REVISED DEFINITION OF RETAIL MERCHANDISE SALES PERIMETER WALL LENGTH AND GROCERY STORE LIGHTING POWER

July 24, 2026

Docket No. 25-BSTD-03

Figure 2: Distribution of Grocery Store Total Lighting Power Densities (W/ft²)

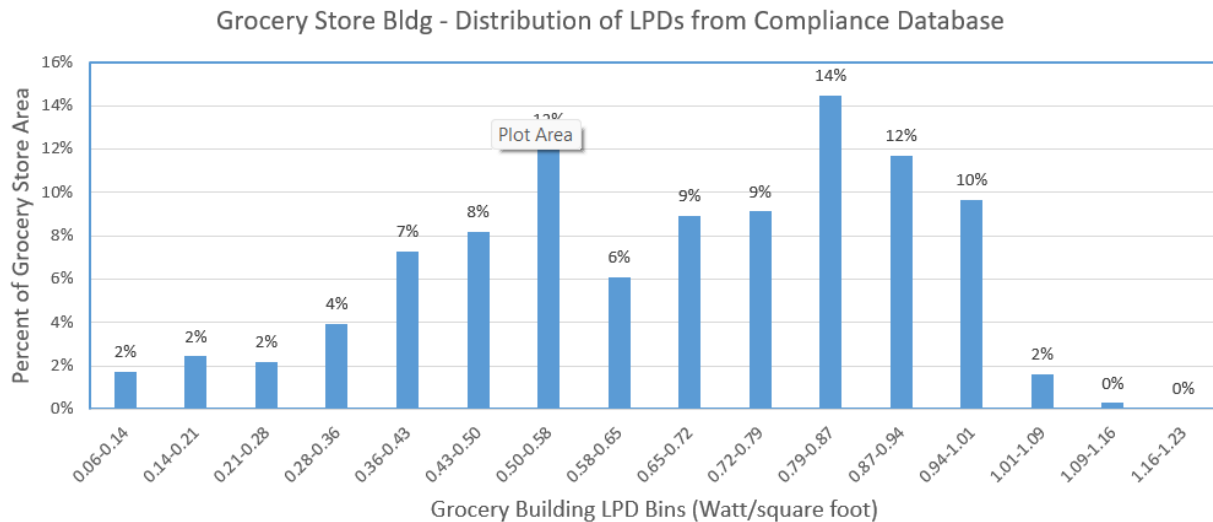
A database of 2022 California Energy Code prescriptive compliance building data including total building LPD was evaluated by building type. This includes the lighting data from all prescriptive compliance paths (Complete Building Method, Area Category Method and Tailored Method). Figure 2 contains a summary of the fraction of grocery store area with respect to whole building LPD.

Notable results from this evaluation are as follows:

- Highest³ grocery building LPD in the database is 1.18 W/ft²
- Median LPD is 0.60 W/ft²
- Average LPD is 0.65 W/ft²
- 97th percentile is 1.0 W/ft² and less.

³ Note that highest histogram bin is 1.16 to 1.23 W/ft² in Figure 2 but highest value in that bin is 1.18 W/ft².

Figure 3: Specialty Grocery Store Layout (Model 1) Luminaire Schedule and Wattage Calculation

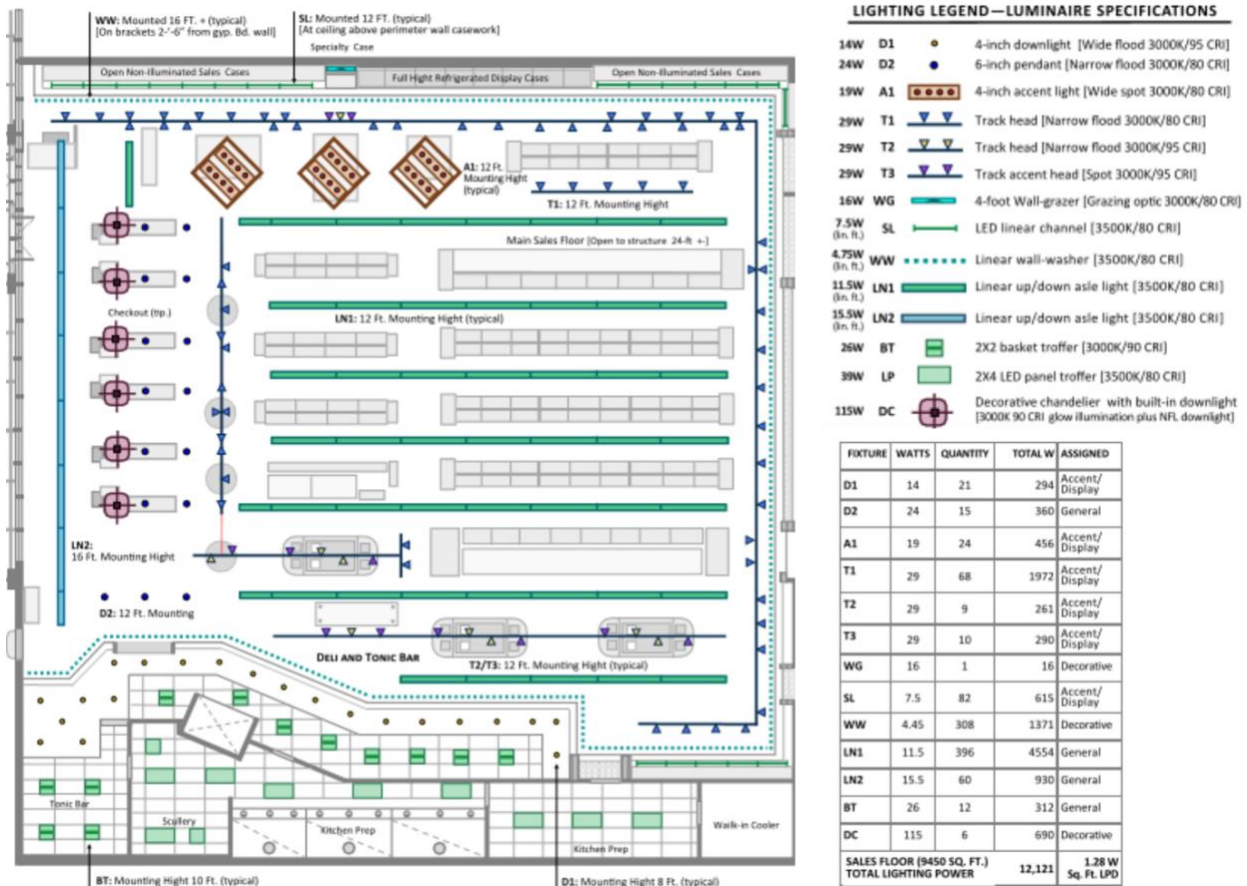
Figure 3 illustrates the first of these models with a significant amount of ornamental and display lighting. Illumination targets are:

- Base lighting 50-60 fc,
- Highlighting 70-80 fc,
- Accent lighting 150-350 fc and
- Vertical wall illumination of 40-50 fc.

The primary form of general illumination in Model 1 is provided by linear pendants mounted at 12 feet which have an indirect/direct luminance distribution pattern that brighten the 24 foot high ceiling while placing lighting down on the sales floor. Downlights provide task lighting by checkout and by deli areas, as well as some circulation lighting. Decorative chandeliers over check-out provide aesthetic interest and

useful task lighting. Lighting track supports flood and spotlights for highlighting merchandise and brightening wall surfaces that may contain signage or other graphics. The three gondolas in the upper right portion of the plan have custom suspended casework containing 24 accent lights that are 19 watts each. The perimeter, except the exit side of the store near check out, has linear wall washers that brighten the upper wall surfaces of this space. The overall lighting power density of this space with many design features requires 1.28 W/ft².

Figure 4: Specialty Grocery Store Layout (Model 2) Luminaire Schedule and Wattage Calculation

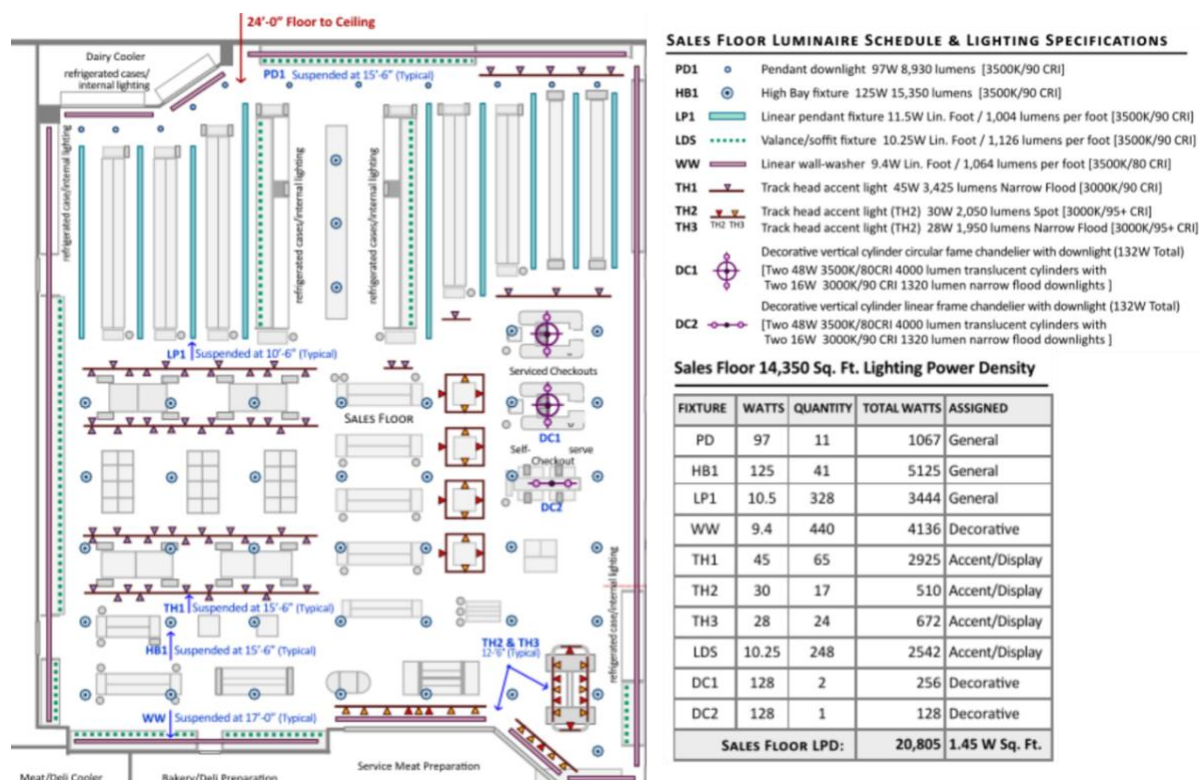
The second model illustrated in Figure 4, has similar illumination targets as Model 1 except for a higher vertical wall illumination target of 60-80 fc. General lighting is provided by linear pendants, high bay fixtures and high-intensity downlights. Checkout lighting is served by decorative cylinder fixtures containing flood lights which place higher levels of light at the financial transaction area. Accent/display lighting is provided by spot and flood lights mounted on track as well as by valence lighting in some of the display cases.
